**Proposed modification of the Cobaki Concept Approval  
(MP06\_0316 Mod 7) with regard to proposed amendments to the  
Cobaki Estate Development Code**

I refer to your email dated 23 March 2017 inviting Council to provide comment on the proposal and provide any recommended conditions. Upon review of the documentation associated with Mod 7, please find below Council's comments:

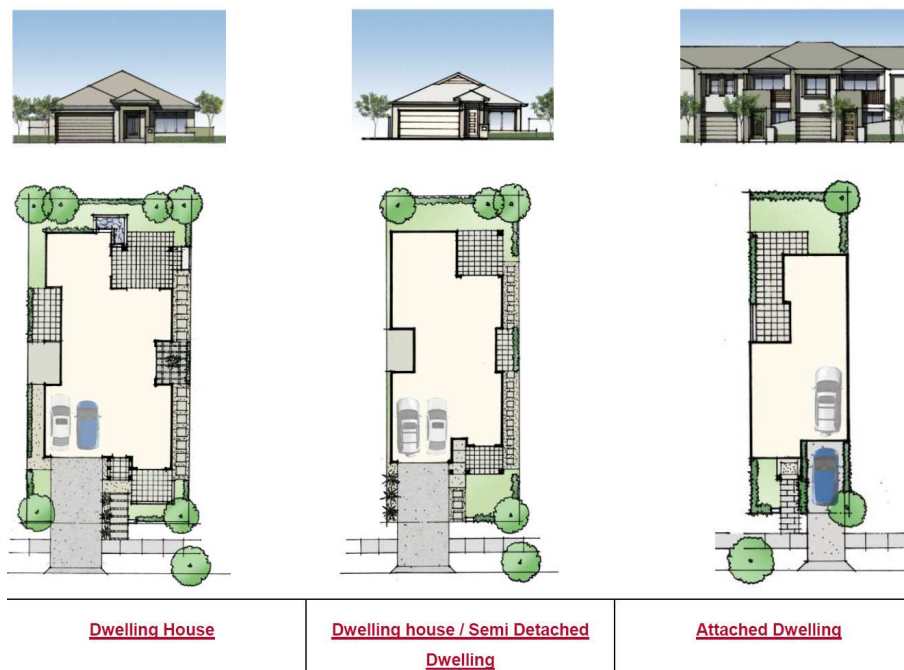
- iii. The proposed 5m wide front access for Attached Dwellings is not supported, unless a rear lane access is provided. The proposed 5m lot width also results in a development not being able to achieve the on street parking requirements noted in Table 5.4.1. As shown in the image below (Page 113 of the Track Changes Code), a driveway at the front of the allotment would not provide sufficient on street parking if a 5m frontage is proposed for this type of development.
